City of Detroit CITY PLANNING COMMISSION

RE: Request of Mariners' Church of Detroit for PC (Public Center) Special District Review of proposed exterior alterations to 170 East Jefferson Avenue – Mariners' Church of Detroit

(RECOMMEND APPROVAL WITH CONDITIONS)

Following is the review by the Planning and Development Department (PDD) of the Mariner's Church Master Plan for 170 E Jefferson Ave. (BSEED Permit number BLD2022-02014). The church was listed on the National Register of Historic of Historic Places in 1971. As the property is zoned PC (Public Center), this review is required under Sec. 50-11-96 of the City of Detroit Zoning Ordinance.

WEST ELEVATION

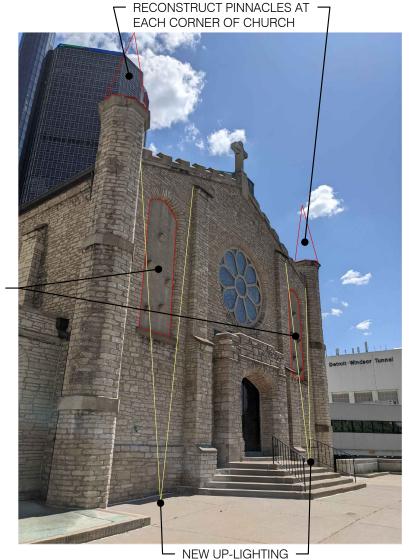
- 4. Niches. Masonry infill in two locations on the west façade (facing Hart Plaza) is proposed to be removed at original building openings. A new glass fiber reinforced cast niche is proposed for the display of statues by the owner. Details of the statues were not provided.
- 5. Additional improvements include: relocating the existing historic marker facing East Jefferson Avenue to the northeast corner of the site, removal of existing foundation plantings along the north side of the building, removal of concrete near the sign that has been removed

Criterion 14 Preservation/restoration of buildings having architectural or historic value should be considered a primary objective; Relocating of Historic marker to the corner on the west elevation tuckpointing of masonry walls, drainage updates, up lighting to bring attention to architectural detail of the north, east and west elevations building, removal of light pole on the west elevation, restoration of pinnacles on all elevations of the building by matching historical precedent, modifying niches for the display of statues on the west elevation by removing masonry infill, and appears appropriate.

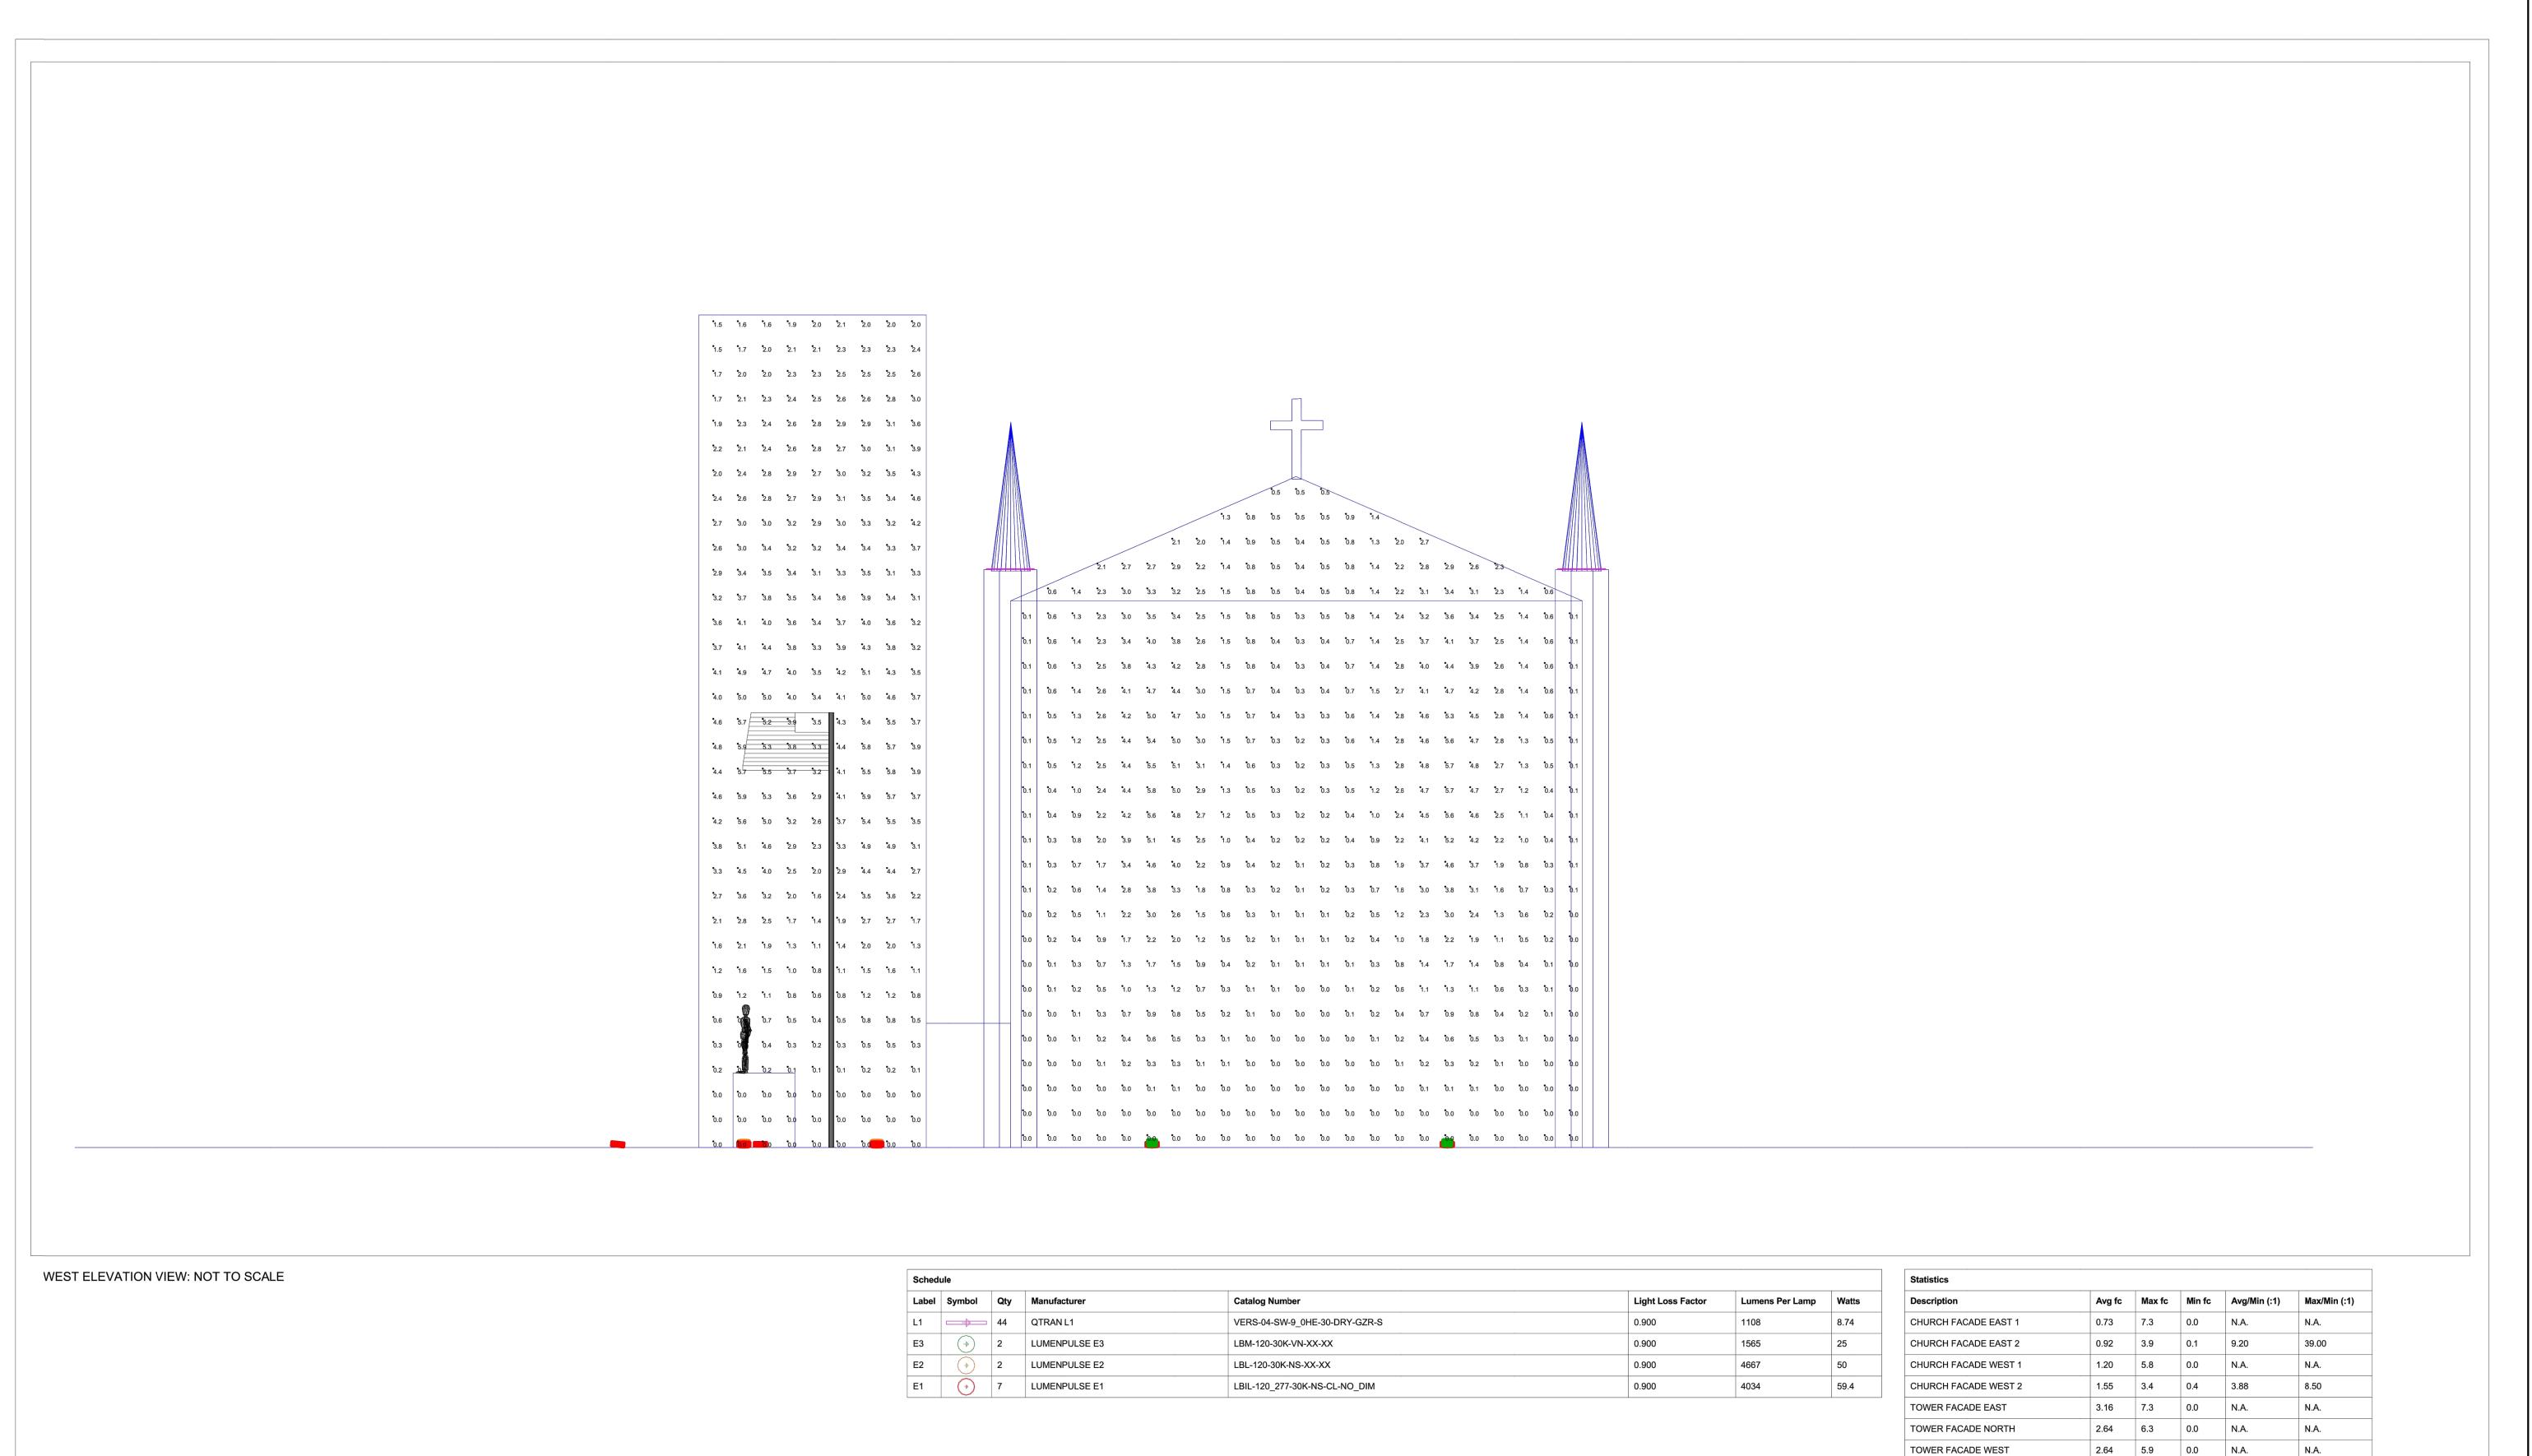
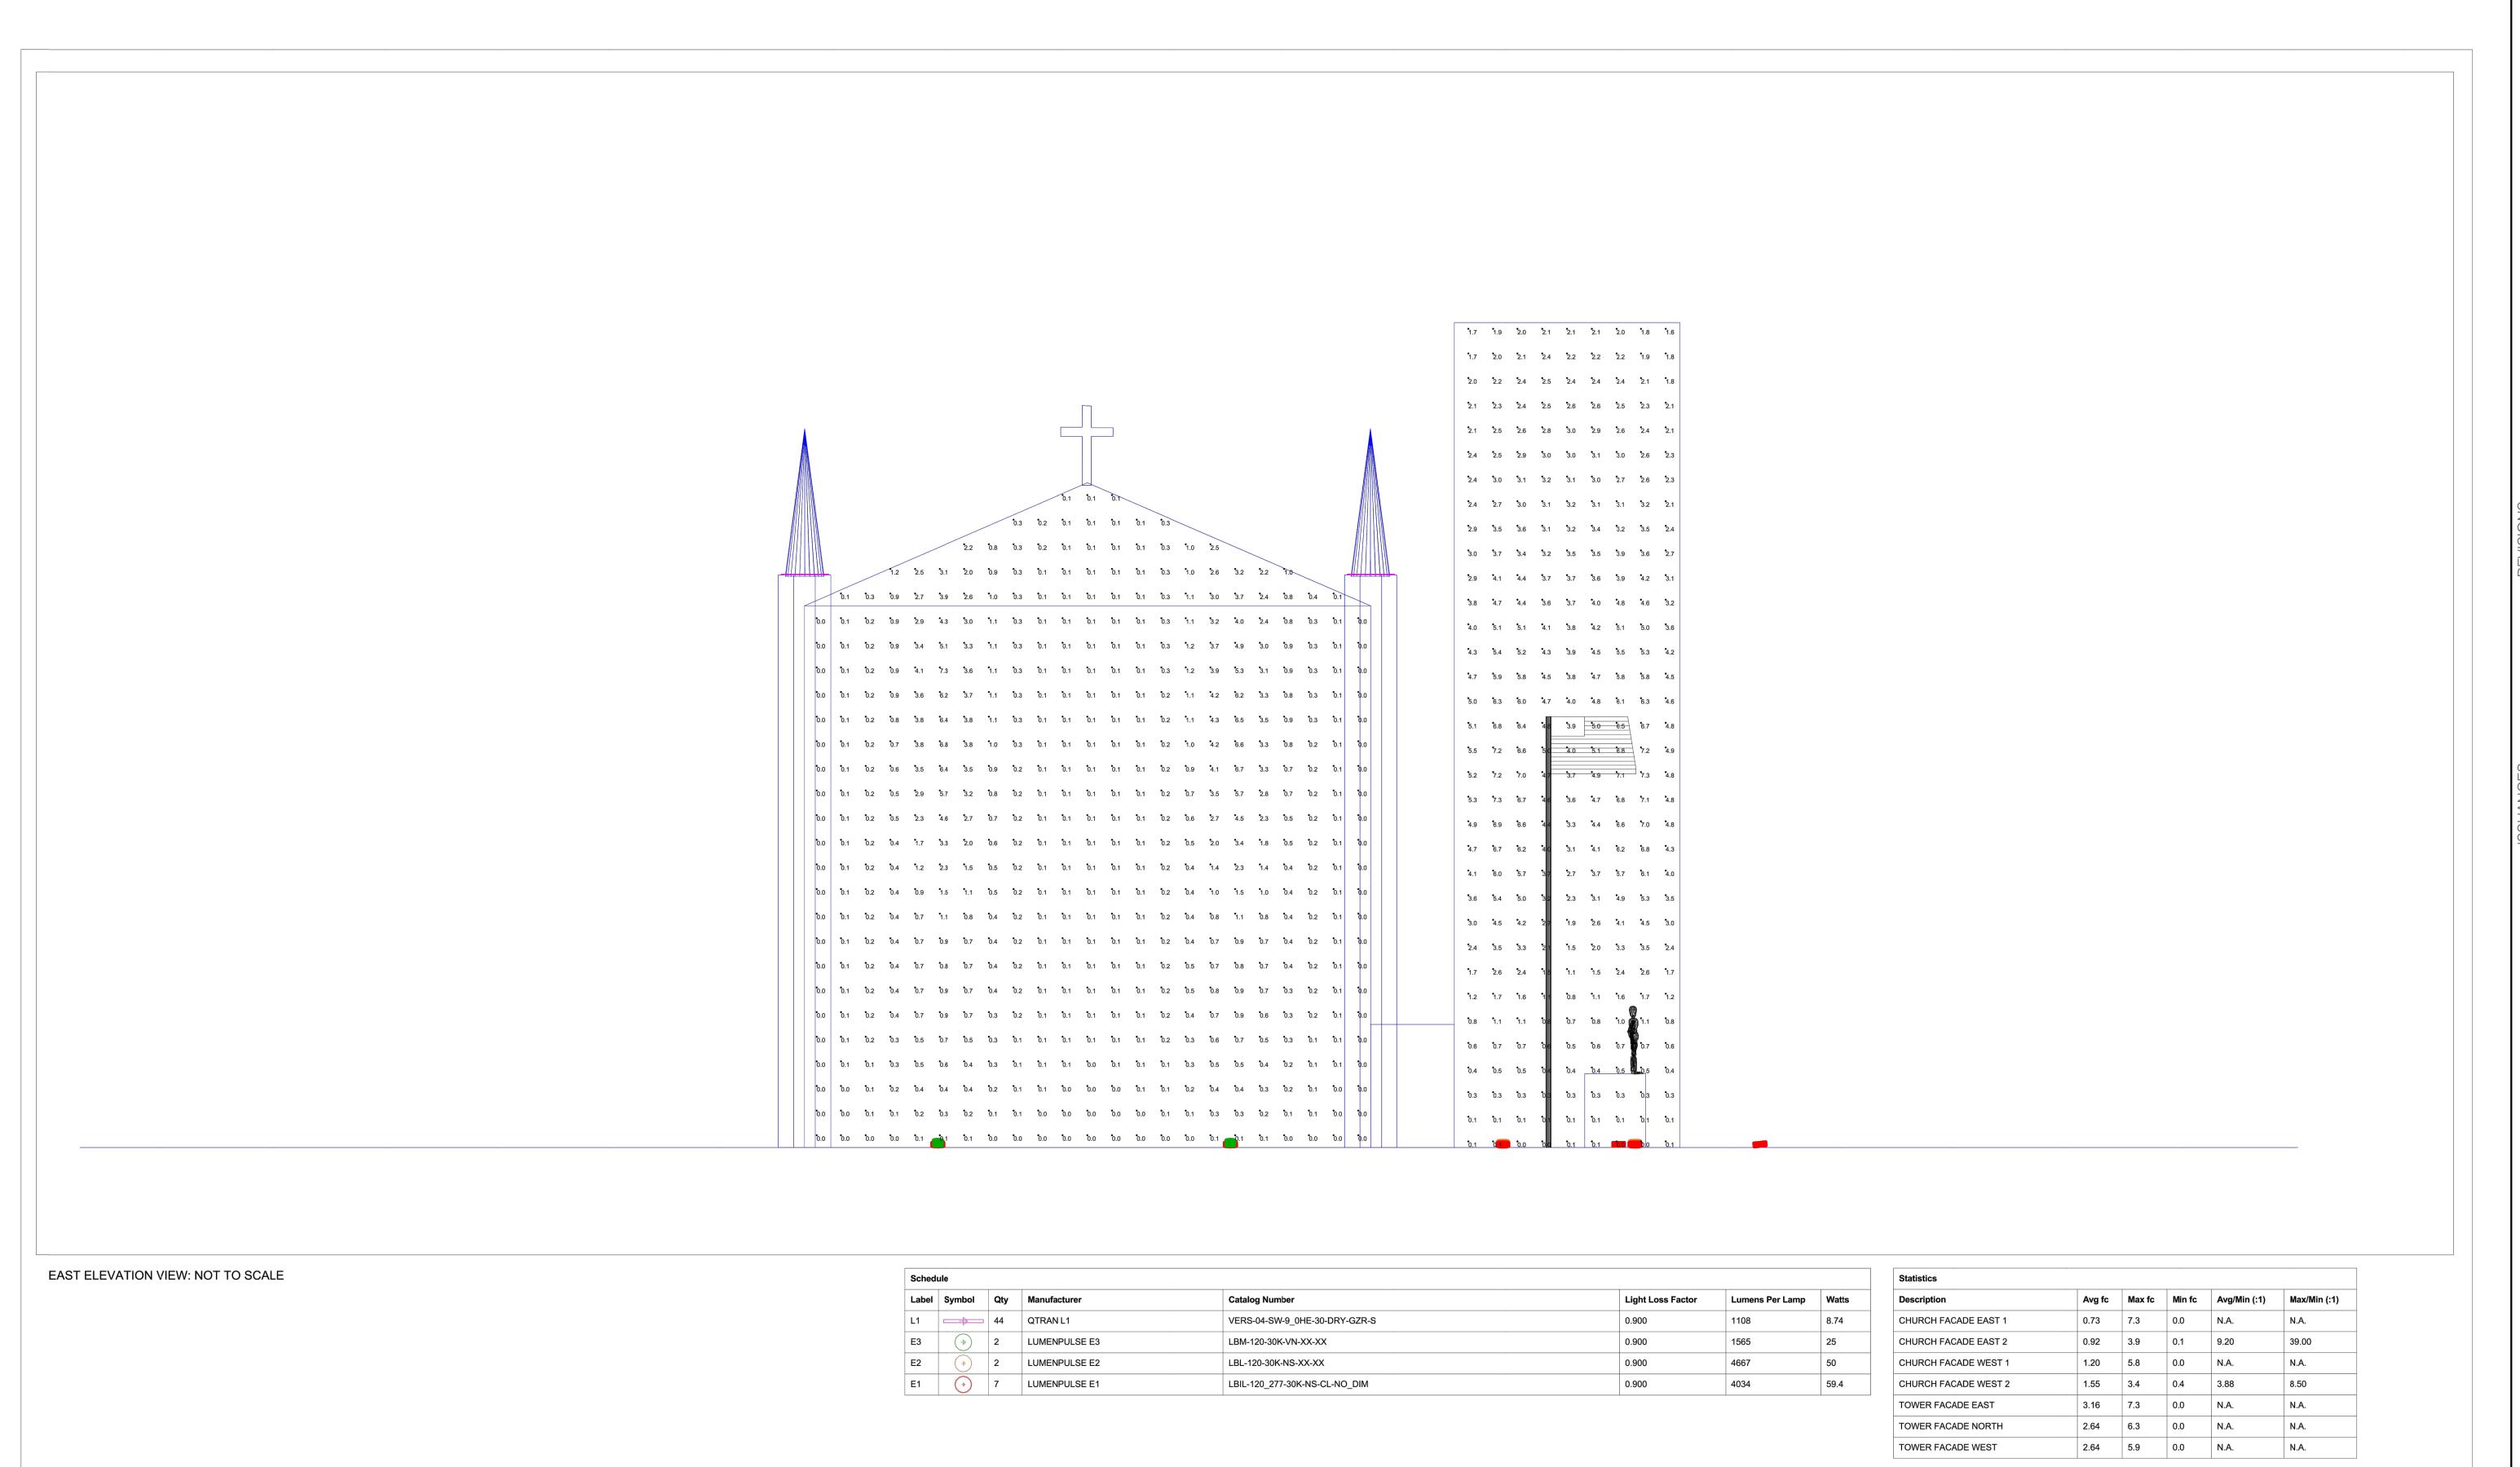
- b. CPC staff finds that the revised Site Lighting plan dated July 28, 2022, would take reasonable measures to limit light spillover and nightglow as illuminance levels depicted on sheets A106, A108, and A110 indicate that the highest levels of illuminance would be focused on building facades, the tower, and pinnacles, and would not be focused off-site or directly into the sky. Additionally, there are numerous examples of buildings, especially churches, located within the Central Business District that have similar focused up-lighting provided.
